Item Name: Crosstube Turning Detail

DART AEROSPACE LTD		Work Order: 144334
Description: Crosstube Assembly (206B High Fwd)		Part Number: D206-667-141
Inspection Dwg: D206-667-141 Rev: C		Page 1 of 2

DRAWING NO. D206-667-141	TITLE CROSSTUBE ASS'Y (206B HIGH FWD)	REV. C	DART AEROSPACE LTD ENGINEERING ORDER		D.E.O. NO. D206-667-141-C-1	SHEET NO. SHEET 1 OF 1	SCALE NTS
DRAWN <i>q</i>	CHECKED <i>ASS</i>	MFG. APPR. <i>JD</i>	APPROVED <i>MD</i>		DE APPR. <i>HA</i>		
DATE 11.07.15	DATE 11.07.20	DATE 11.07.21	DATE 11/07/21		DATE 11.07.21

DRAWING NO. D206-667-141		TITLE CROSSTUBE ASS'Y (206B HIGH FWD)		REV. C	DART AEROSPACE LTD ENGINEERING ORDER		D.E.O. NO. D206-667-141-C-2	SHEET NO. SHEET 1 OF 1	SCALE NTS
DRAWN AJS		CHECKED		MFG. APPR. <i>E</i>		APPROVED <i>AP</i>		DE APPR. <i>AP</i>	
DATE 12.08.02		DATE 12.08.02		DATE 12.08.02		DATE 12.08.02		DATE 12.08.02

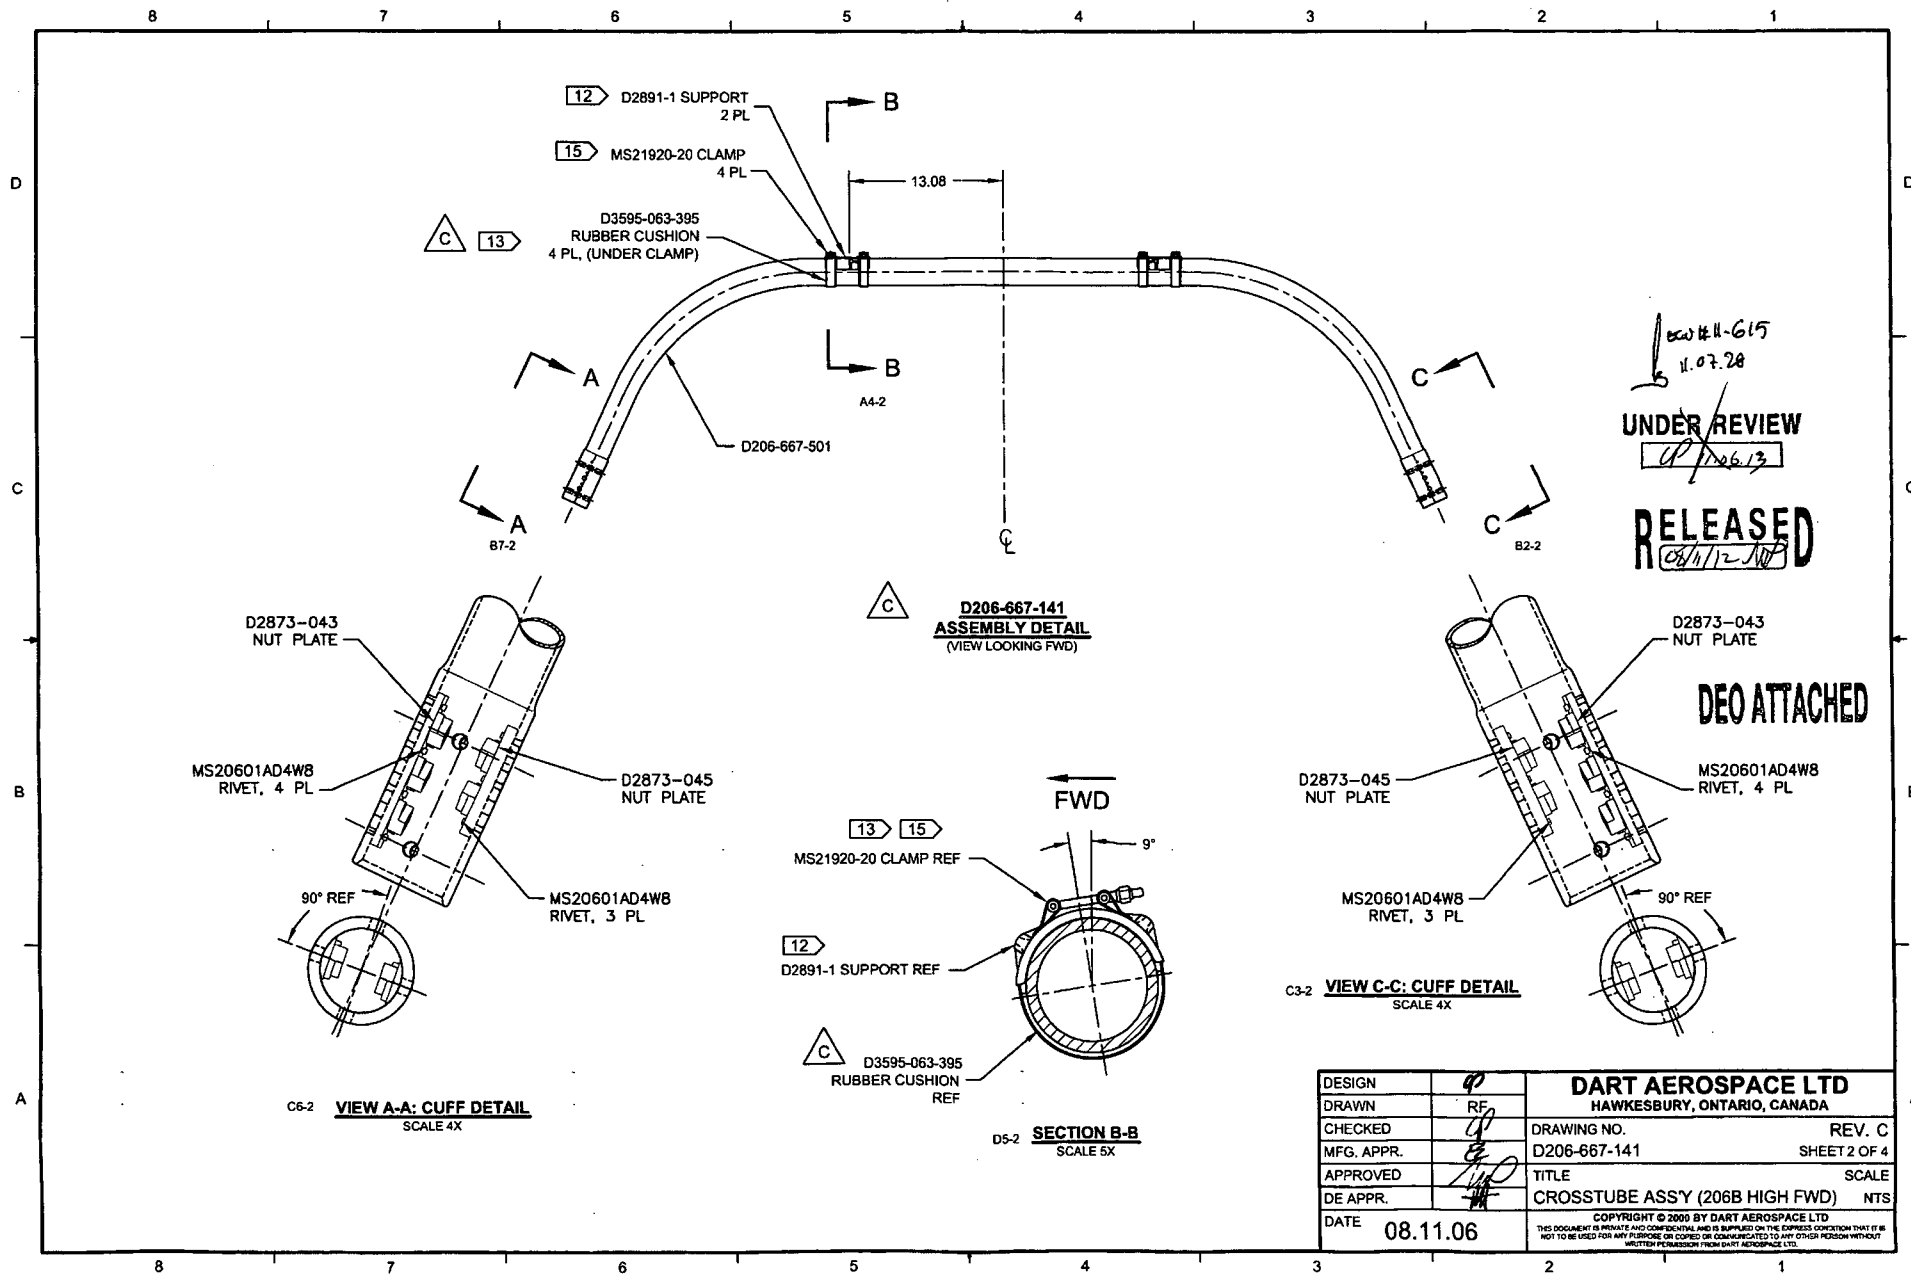
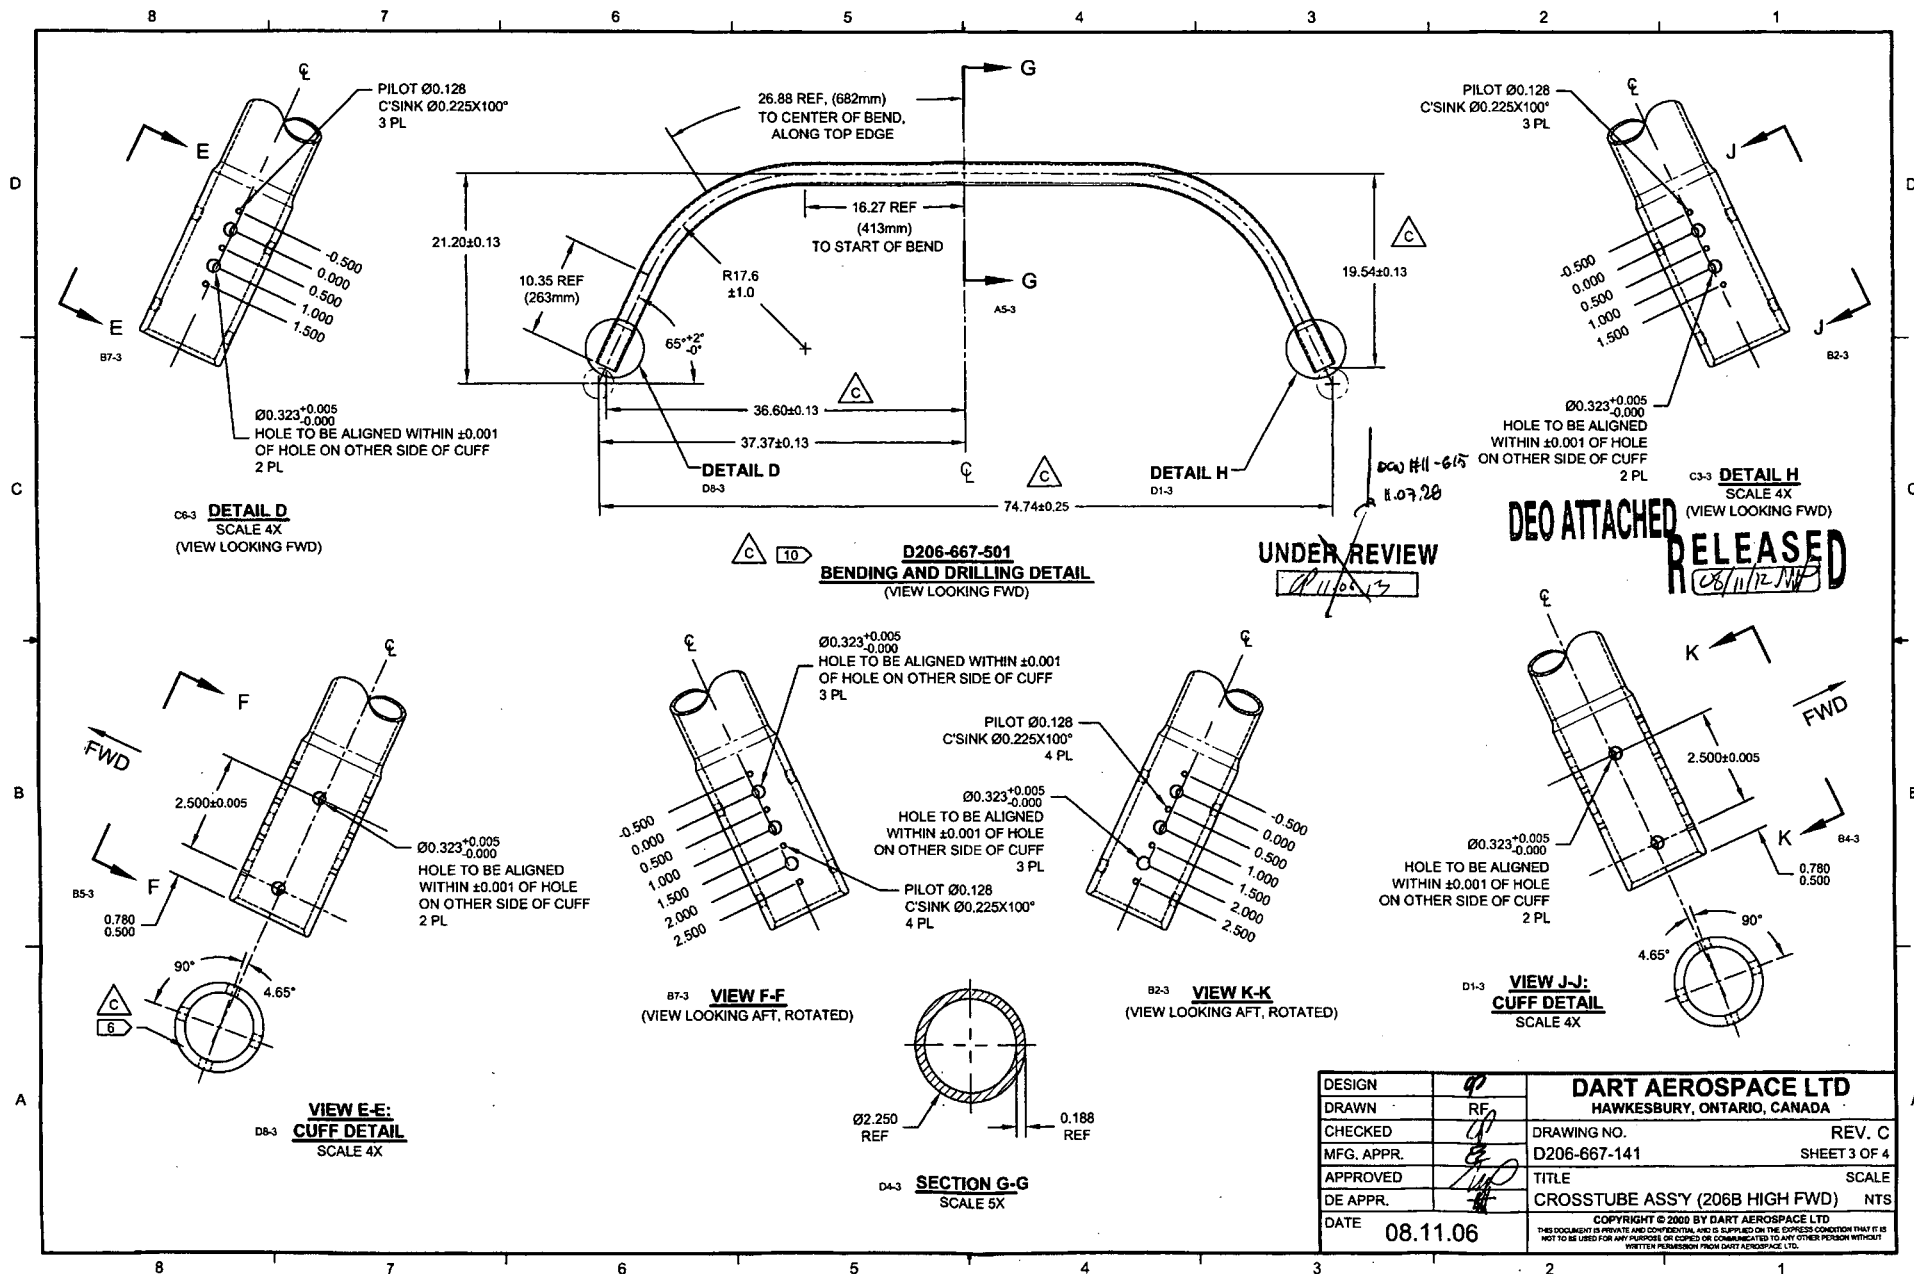
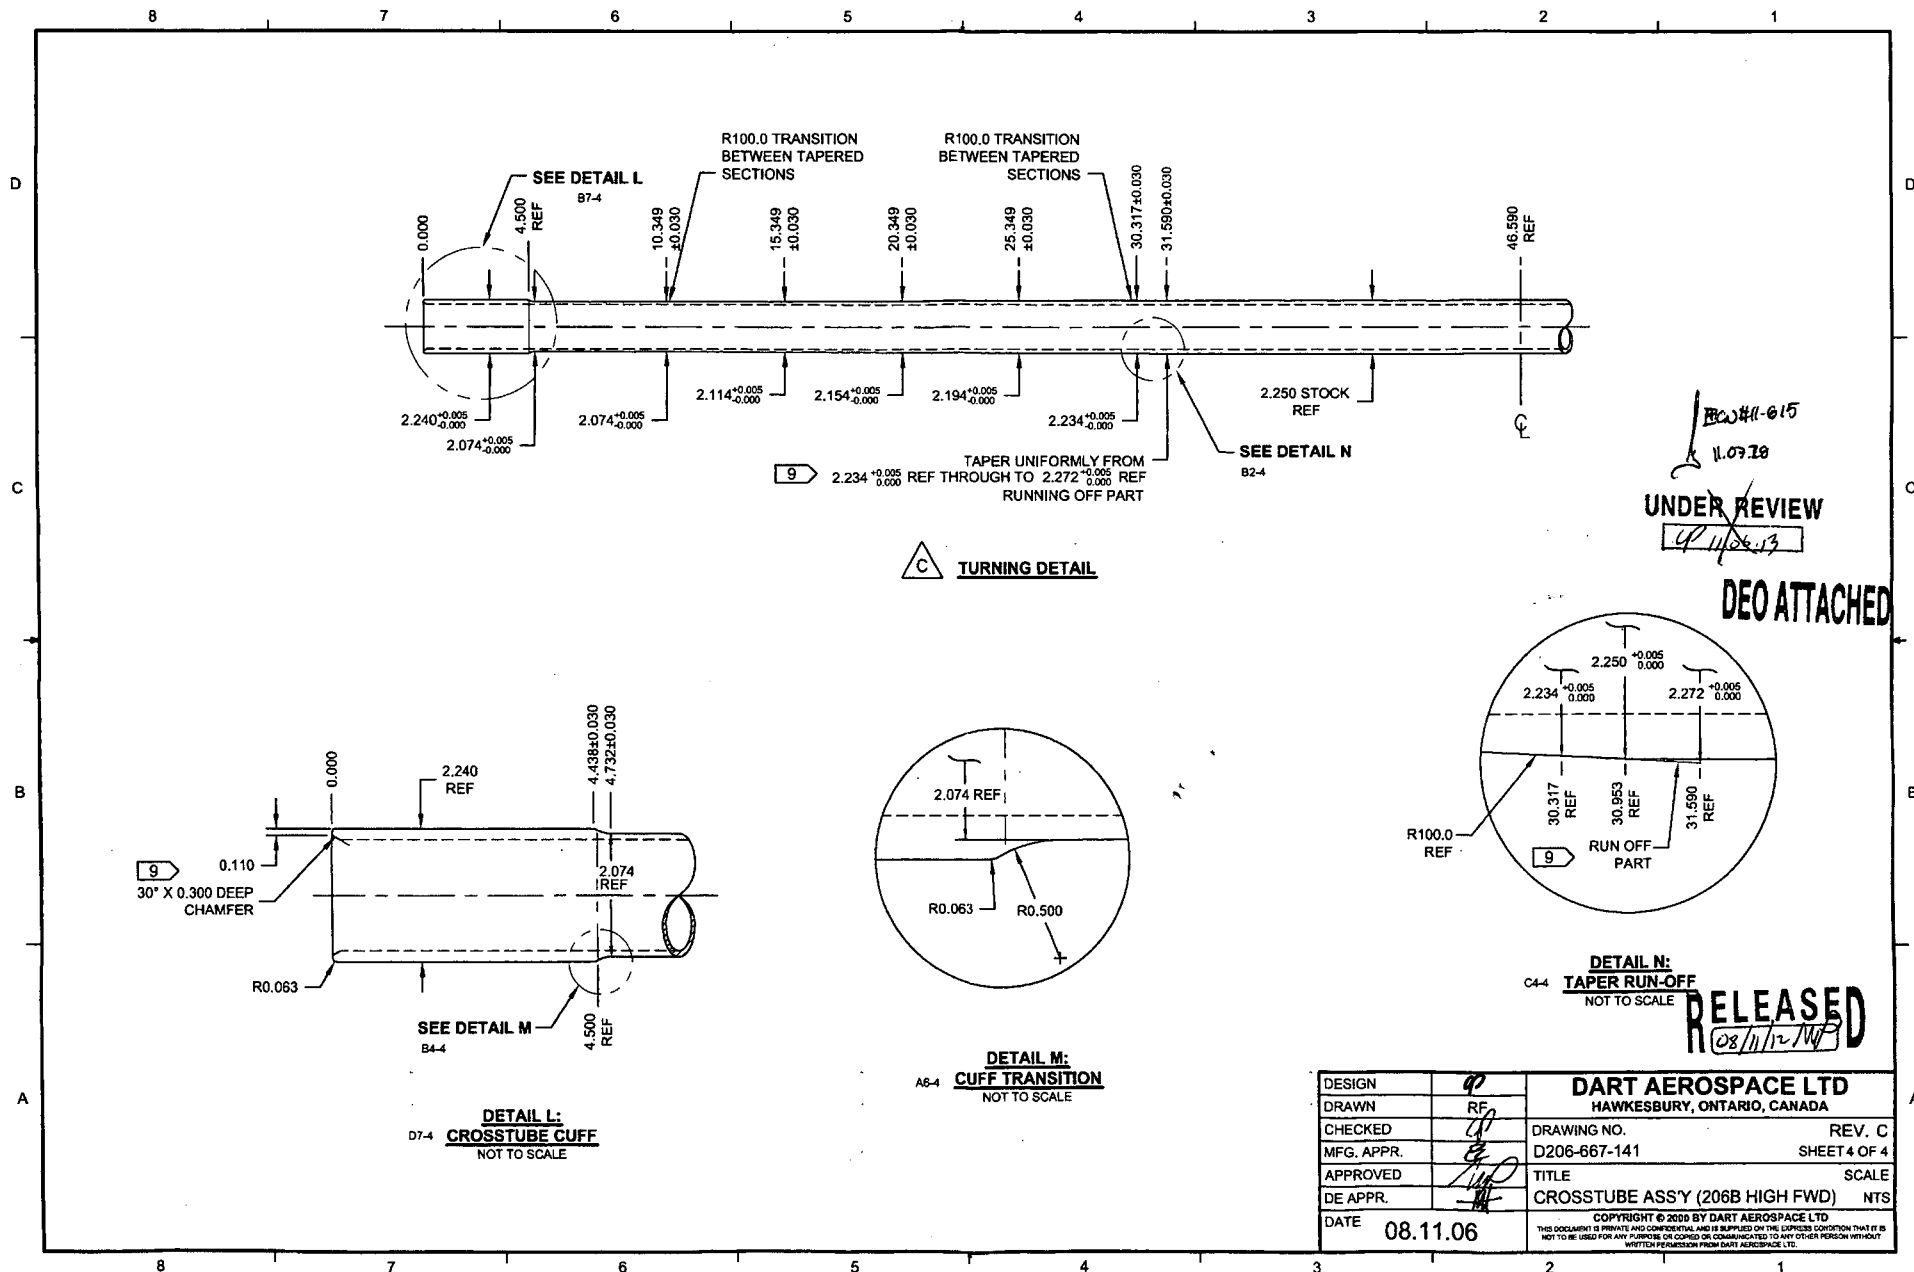
C	REVISE GENERAL NOTES/PART LIST (ZN D7-1); REORGANIZED VIEWS AND REFORMATTED DRAWING TO CURRENT STANDARDS. D3595-063-395 WAS D2856-400-694 (ZN D6-2 & A5-2); REMOVED REF. & ADD TOLERANCES (ZN C4-3, C5-3 & D3-3); RELOCATED FLAG #6 (ZN A8-3) PER NCR 210; MOVED TURNING DETAIL & UPDATED TOLERANCE TO SHEET 4.	RF	08.11.06
B	ADD HOLES AND NUT PLATES FOR COMPATABILITY WITH BHT/AA SKUDTUBES	PH	05.07.26
A	NEW ISSUE	CP	00.11.17
REV.	DESCRIPTION	BY	DATE
DESIGN	RF	DART AEROSPACE LTD HAWKESBURY, ONTARIO, CANADA DRAWING NO. D206-667-141 REV. C SHEET 1 OF 4 TITLE CROSSTUBE ASS'Y (206B HIGH FWD) SCALE NTS COPYRIGHT © 2009 BY DART AEROSPACE LTD THIS DOCUMENT IS PRIVATE AND CONFIDENTIAL AND IS SUPPLIED ON THE EXPRESS CONDITION THAT IT IS NOT TO BE USED FOR ANY PURPOSE OR COPIED OR COMMUNICATED TO ANY OTHER PERSON WITHOUT WRITTEN PERMISSION FROM DART AEROSPACE LTD.	
DRAWN	RF		
CHECKED	RF		
MFG. APPR.	RF		
APPROVED	RF

DETAIL P
BONDING STRAP INSTALLATION 2 PL

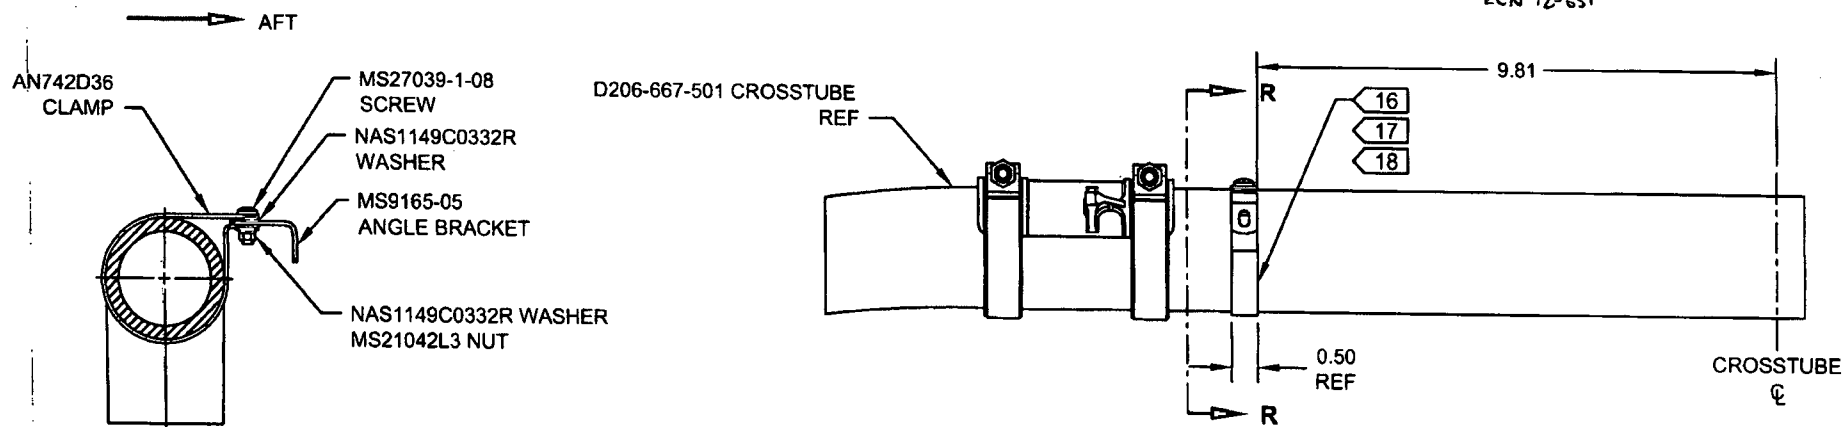
ADD ELECTRICAL GROUNDING STRAP

ADD

- 16) MASK AREA UNDER CLAMP PRIOR TO PAINTING
- 17) SEAL EDGES WHERE AN742D36 CLAMP MEETS WITH THE CROSSTUBE USING SIKAFLEX-241/-291 OR MIL-S-8802 CLASS B2 OR PROSEAL 890 SEALANT
- 18) PERFORM RESISTANCE CHECK TO ENSURE MAX RESISTANCE IS 10 MILLIOHMS

ITEM	QTY -141	PART NUMBER	DESCRIPTION
1	X	D206-667-141	CROSSTUBE ASSEMBLY (206B HIGH FWD)
10	2	AN742D36	CLAMP
11	2	MS9165-05	ANGLE BRACKET
12	2	MS21042L3	NUT (OR MS21042-3)
13	2	MS27039-1-08	SCREW
14	4	NAS1149C0332R	WASHER (OR AN960C10L)
